RE:Design Exception for Dove Landing SubdivisionLocation:2758 Unaweep Ave.Submitted by:Dave Eddy and Linda Stolte – Dove Landing

## **DESIGN EXCEPTION #6-06**

To:	Mark Relph, Director of Public Works & Utilities Bob Blanchard, Director of Community Development Rick Beaty, Fire Chief
From:	Tim Moore, Public Works Manager
Copy to:	Laura Lamberty
Date:	February 10, 2006
RE:	2758 Unaweep Ave. Driveway Offset and Spacing

DE# 6-06 2758 Unaweep Ave. Driveway Spacing

## 2758 UNAWEEP Dove LANDING

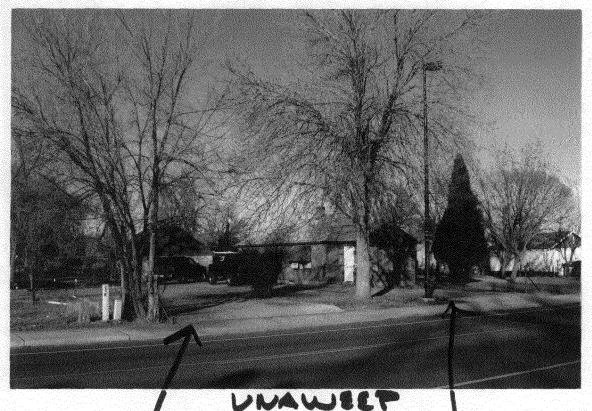
This is a request for an Exception to the 150' minimum offset for proposed driveway access off Unaweep. The current access to this property is a double driveway approximately 40' wide and is located on either side of an existing city light pole. The current drive is located 170' from Mountain View St. and 120' from Cherry Lane on the North side of Unaweep. (Please see diagram #1) Due to the irregularity of Cherry Lane on the opposite side of the street the current drive is approximately 80' from the south side of Cherry –(Cherry Lane to the south is a short no outlet street with low traffic)

We would propose a single main access of 28' in width to occur in approximately the same location as the existing drive which is furthest east. The existing drive (furthest west and closest to Cherry) would be closed and the new entrance would be built to city standards with radii per TEDs chapter 4. By closing the existing west side drive and locating the access further east we can increase the distance to Cherry to 140' from the current 120' and improve the separation. This drive would still be greater than 150' from Mountain View and would be greater than 140' from Cherry Lane on the North side of Unaweep. This would also increase the separation from Cherry Lane on the south side of Unaweep from 80' to 100'. The other alternatives explored shortened the offset to Cherry lane and created a straight street rather than a curve. The curved entry design should also help traffic flow as it is intended to slow the traffic upon entry and exiting the site.

The proposed access improves the current offset and separation distances from Cherry Lane so the impact of this request should result in an improvement over the current access.

Close off EXISTING DBIVE

PROPOSED LOCATION OF 28' WIDS ACCESS DRIVE

The property currently has two access points on Unaweep Ave. With the development of the site, the access points will be limited to only one access point located approximately 146 feet from Cherry Lane, approximately 102' from the nearest driveway to the west and approximately 81' to the nearest driveway to the east. TEDS requires 150' between driveways or intersections on a collector street.

- 1. Will the exception compromise safety? Staff does not believe the exception will compromise safety.
- 2. Have other alternatives been considered that would meet the standard? Due to the narrow lot frontage and existing surrounding driveways, the applicants options are limited.
- 3. Has the proposed design been used in other areas?

Staff recommends approval of the exceptions requested.
